ADDENDUM NO. 2

ADDENDUM DATE: February 1, 2012
PROJECT: DOBBS SCHOOL UPGRADES
VOCATIONAL BUILDING
OWNER: NC DJJDP
PROJECT NO. PDC Project #10053
SCO # 10-08517-01A
Code # 24060, Item # 23789802
ENGINEER: Progressive Design Collaborative, Ltd.
2900 Rowland Road, Suite 100
Raleigh, North Carolina 27615
Phone: (919) 790-9989
Fax: (919) 790-9367
BID DATE: February 9, 2012 at 3:00 PM

10053
AD-E2-02

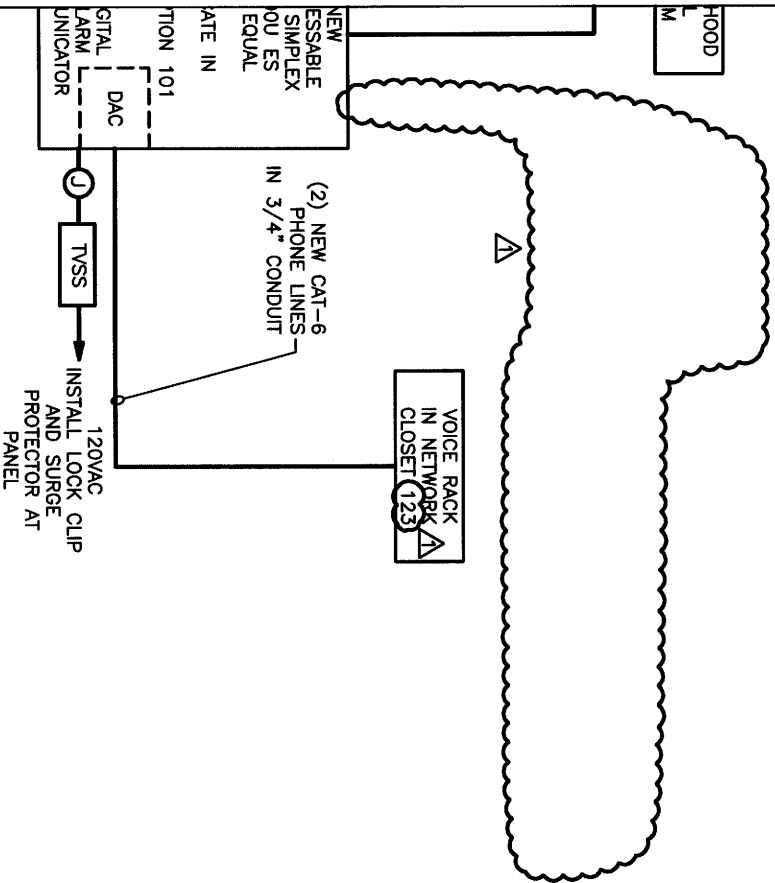
2. Sheet E-2 (Sketch AD-E2-02)
 - Revised Demolition Note 3.
3. Sheet E-5 (Sketch AD-E2-03)
 - Revised fire alarm riser.
 - Revised fire alarm riser notes.
4. Sheet E-5 (Sketch AD-E2-04)
 - Deleted extra horn strobe in Room 101 Reception.
 - Deleted RACP at Lobby 100.

3. THE GENERAL CONTRACTOR SHALL BE RESPONSIBLE FOR PATCHING ANY HOLES IN REMAINING WALLS RESULTING FROM THE REMOVAL OF ELECTRICAL DEVICES.
CLOSE COORDINATION IS REQUIRED BETWEEN THE ELECTRICAL AND GENERAL CONTRACTORS.
